Access Compliance Report

(Curb Ramps)

| Intersection ID: 3809 | Main Street: MOUNTAIN_TRAIL_DR | Cross Street: MT_ISLE_HARBOR_DR | Location: NE |
| ADA ID: C2BEE8794D94 | Ramp Type: Perp | Initial Pass/Fail: Fail | Overall Compliance: No |

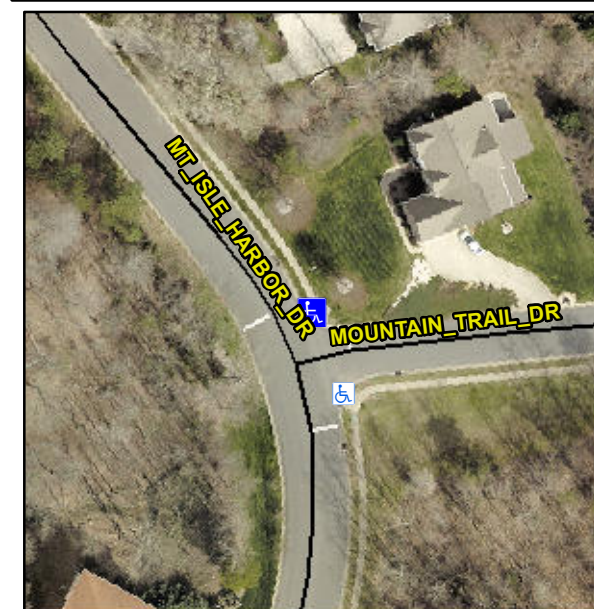
R304.5.1, R304.5.3

| Compliance | Description | Data | Compliance | Description | Data |
|------------|-----------------------|------|------------|-----------------------------|------|
| No | Ramp Width (in) | 47.5 | No | Ramp XSlope (%) | 2.1 |

Remove & Replace Entire Ramp.
